Response to Questions from Mr and Mrs Cameron – 10 May 2020

Thank you for your considered questions on the assessment outcomes and we apologise where our previous replies did not provide sufficient information. It is worth noting that we are in the final stages of preparing the Environmental Impact Statement (EIS) for the Project and shortly expect to have this documentation available for you to review. Many of the reports that we refer to below will be made available with the EIS, which also presents a comprehensive overview of the detailed technical assessment outcomes. A lot of time, effort and expense has been put into the reporting and we anticipate that many of your concerns have also been addressed in the EIS but to a broader perspective. However, we also appreciate that the documentation may seem daunting and we reiterate our offer to answer any queries either in correspondence such as this or where possible, in person or over the phone.

Figure A
SURFACE WATER
MONITORING LOCATIONS

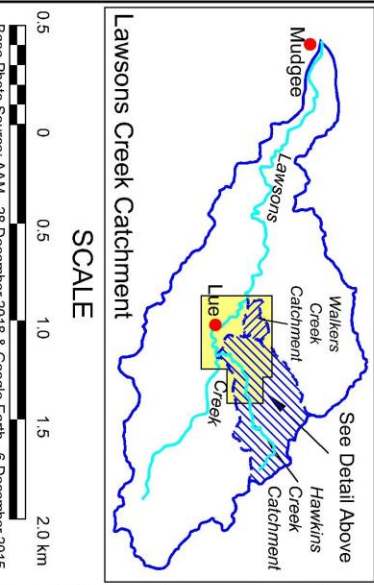
13. *Please advise if monitor BSW28 is upstream or downstream from the causeway on Lawson Creek.*

The monitoring point BSW28 is upstream of the causeway on Lawsons Creek. A figure with the location of BSW28 is provided as **Figure A**.

Figure B
AIR QUALITY MONITORING LOCATIONS
(PROXIMAL TO CAMERON RESIDENCE)

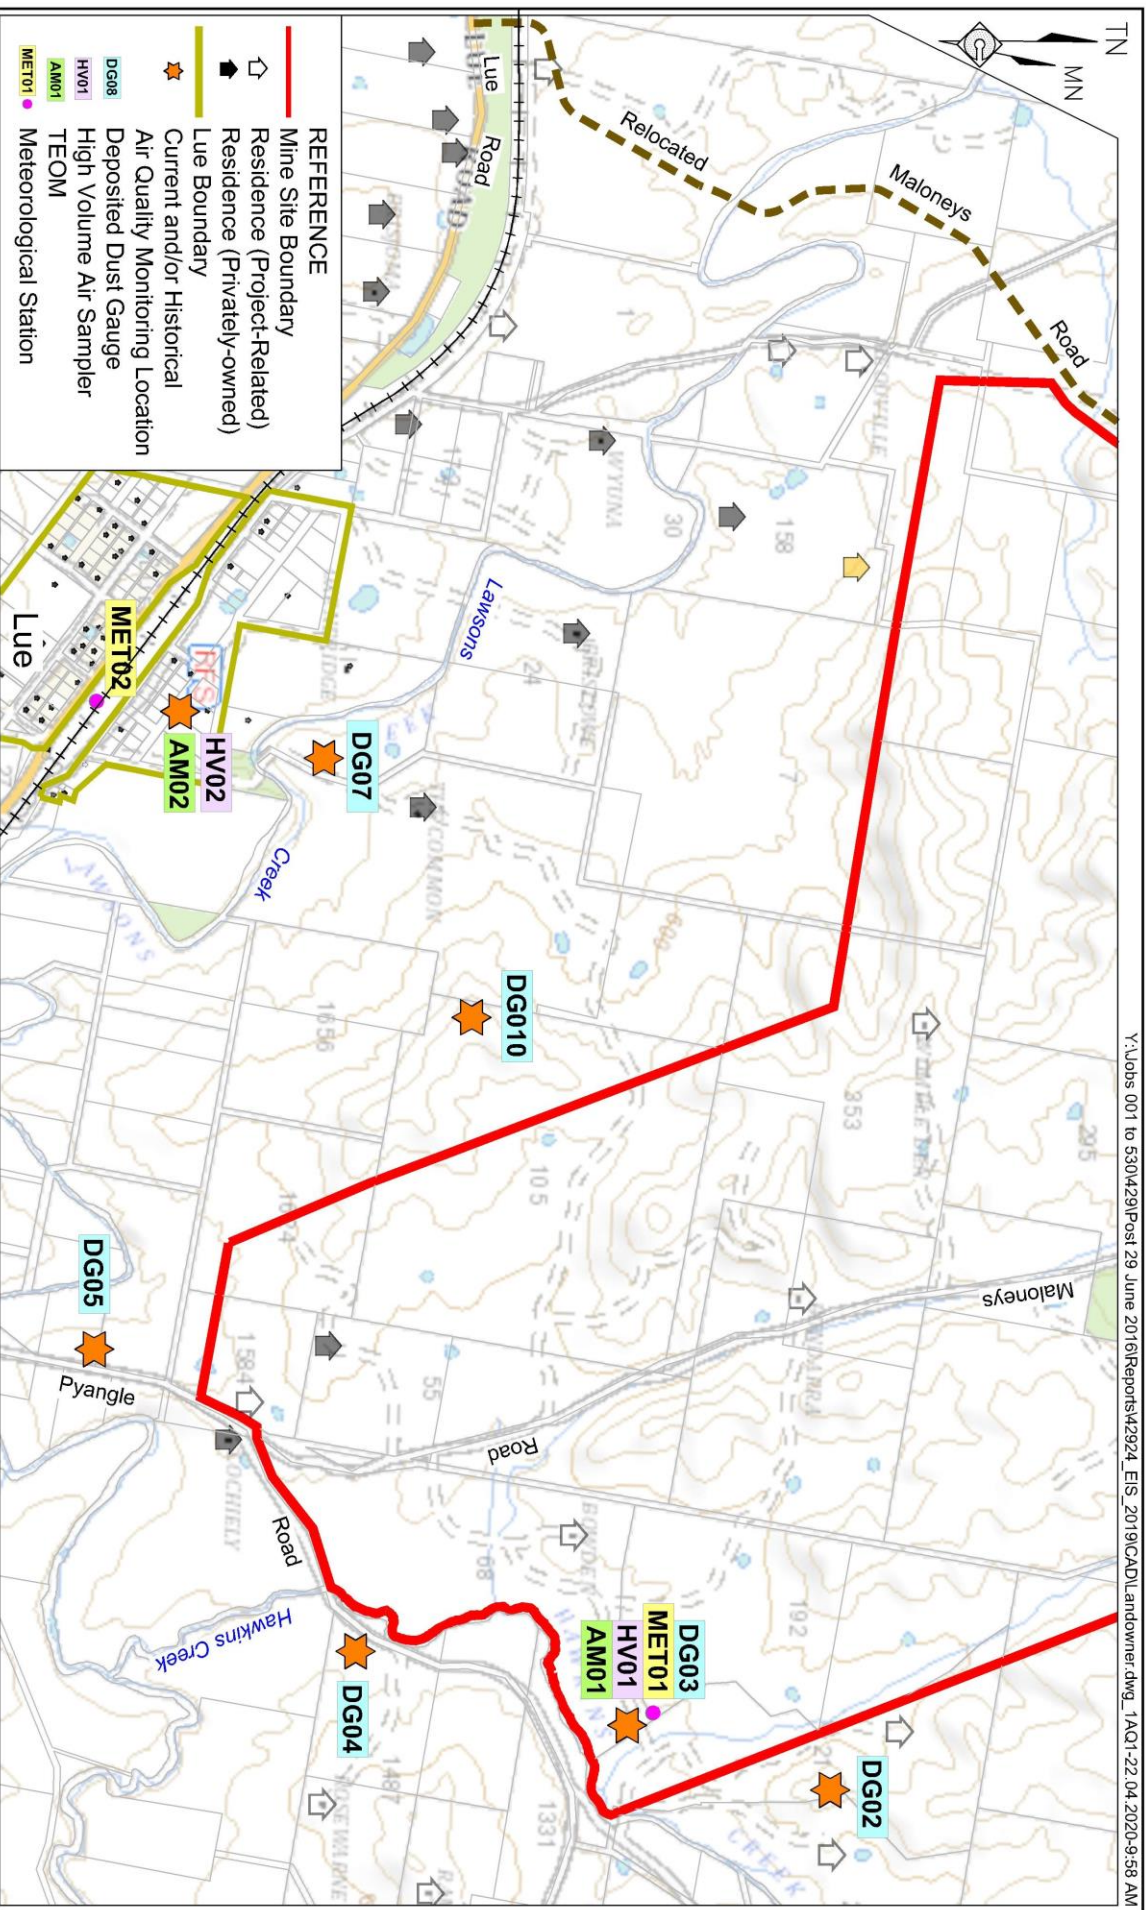
18. *Please advise exactly where DG07 is located, as I cannot find it on the map. Please provide a full copy of the data that has been collected so far.*

BDG07 is a deposited dust gauge located on the property of Mr John Lydiard (in the southwest of his property). The location is displayed on the figure presented as **Figure B**. The following table presents the data collected at BDG07 to date. Please note that this monitor does not record particulate matter (PM₁₀ or PM_{2.5}). Particulate matter has been recorded at the TEOM and high volume air sampler locations (see **Figure B**).
